**SERVICE** *No. 366*  
**LETTER**

Piper Aircraft Corporation

TO: Distributors, Dealers, Certified Service Centers and Owners  
SUBJECT: Nose Gear Clevis  
MODELS AFFECTED: PA-24 and PA-24 "250" Comanches - Serial Nos. 24-1 to 24-2609 inclusive

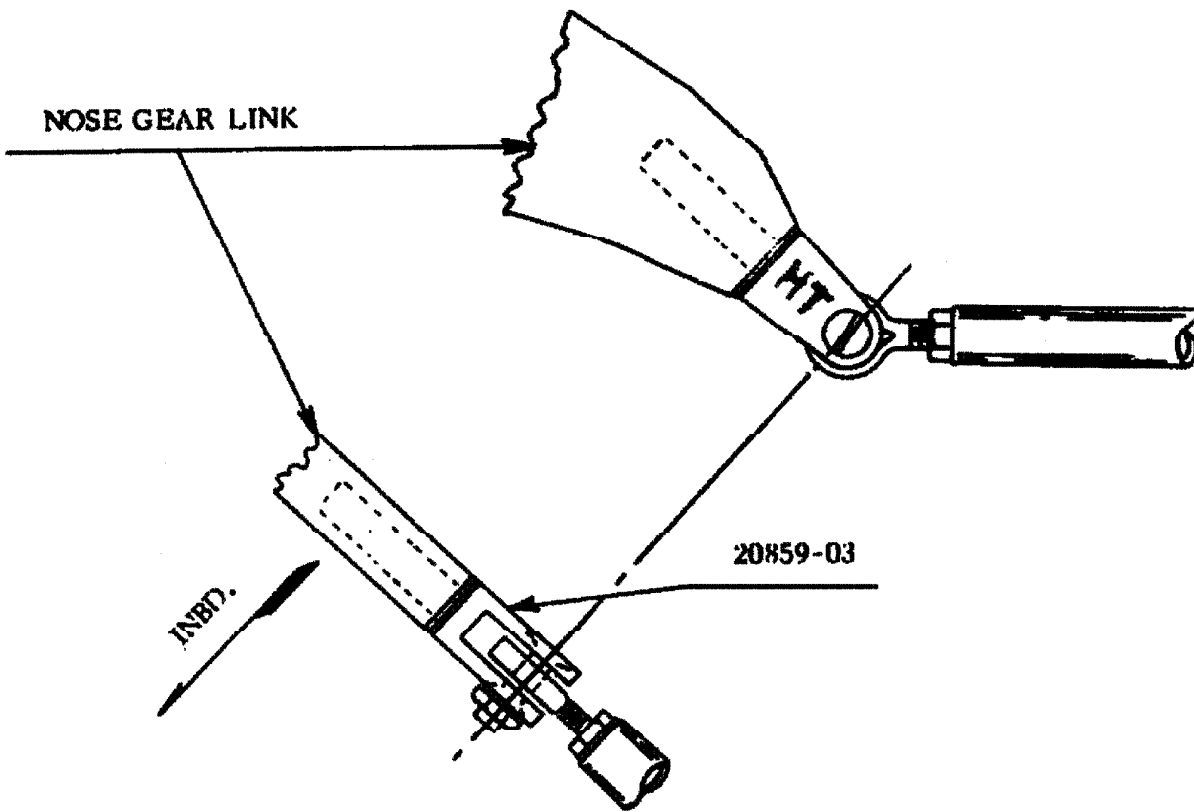
A new high strength nose gear clevis, part number 20859-03, is available to replace the nose gear clevis with which the early models of Comanche aircraft were equipped.

This new clevis may be identified by the letters "H.T." etched on the side of the fitting. We are of the opinion that since this new high strength fitting will provide longer service life, the owners and operators of the affected aircraft should replace the present clevis with this improved one. See sketch below

This clevis, when installed, must be tight in the forgoing (13 to 40 ft. lbs. torque) and nut must be inboard.
